Office Action Summary	Application No. 10/617,758	Applicant(s) POMMERET ET AL.	
	Examiner Jacob Y. Choi	Art Unit 2875

DETAILED ACTION

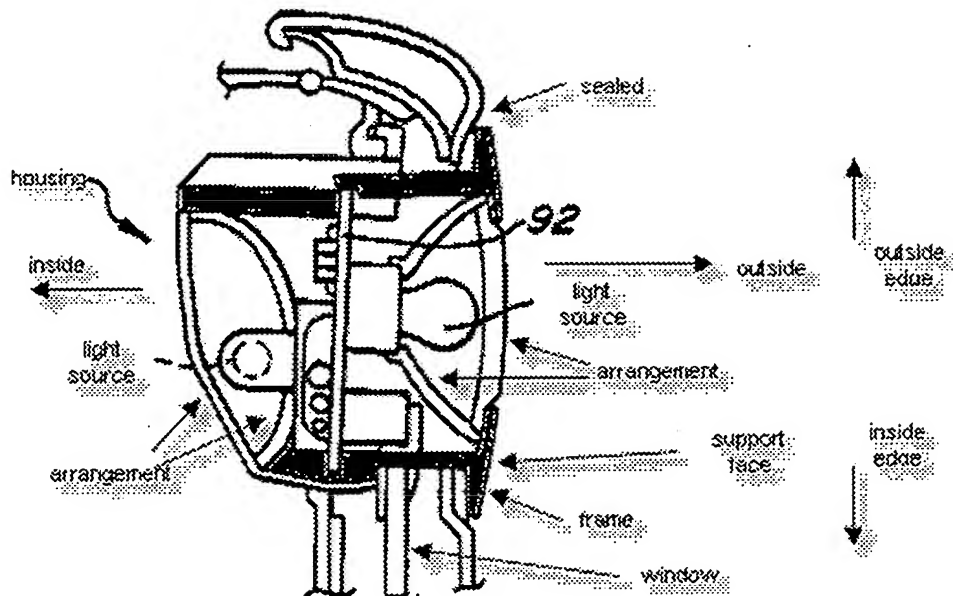
2. Claims 1, 2, & 5 are rejected under 35 U.S.C. 102(b) as being anticipated by Wooldridge et al. (USPN 6,086,230).

Regarding claim 1, Wooldridge et al. discloses the framing including a support face between an inside edge and an outside edge of the framing for being covered by the periphery of the window that is connected in a sealed manner to the outside edge, the framing including an arrangement on the support face for receiving a light source and the frame also including a housing that is opened both towards an outside of the vehicle, and towards an inside of the vehicle, this housing being arranged to receive the light source in such a manner as to enable the light source to emit light out from the housing both towards the outside and towards the inside of the vehicle.

Regarding claim 2, Wooldridge et al. discloses the housing is closed, towards the inside of the vehicle, by a wall that is translucent or transparent (window), and *possibly* provided with a filter (28 or 30), so as to diffuse the light emitted by the light source towards the inside of the vehicle.

Regarding claim 5, Wooldridge et al. discloses the wall is provided with a filter/lens.

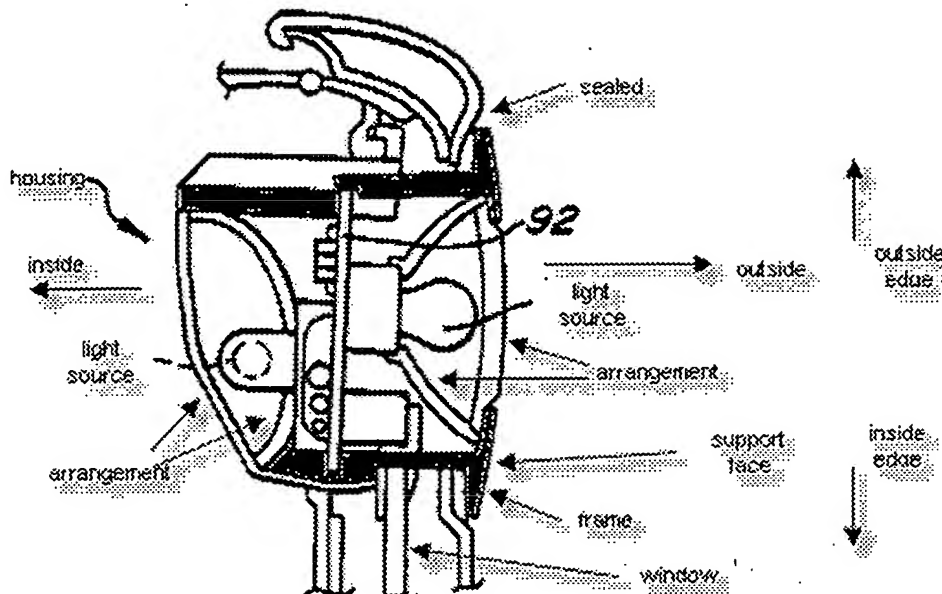
In response to applicant's argument that the references fail to show certain features of applicant's invention, clear element-by-element match has been described below. Things clearly shown in reference patent drawing qualify as prior art features, even though unexplained by the specification. *In re Mraz*, 173 USPQ 25 (CCPA 1972).

Wooldridge et al. (USPN 6,086,230) teaches a frame for a window with a support face between an inside edge and an outside edge of a framing for a window with a support face between an inside edge and an outside edge of a framing for being covered by a **periphery of the window** that is connected in a sealed manner to the outside edge.

Note: claims in a pending application should be given their broadest reasonable interpretation (e.g., "sealed manner"). *In re Pearson*, 181 USPQ 641 (CCPA 1974).

In response to applicant's argument that the references fail to show certain features of applicant's invention, it is noted that the features upon which applicant relies (i.e., "the window DOES cover the support face ... etc.") are not recited in the rejected claim(s). Although the claims are interpreted in light of the specification, limitations from the specification are not read into the claims. See *In re Van Geuns*, 988 F.2d 1181, 26 USPQ2d 1057 (Fed. Cir. 1993).
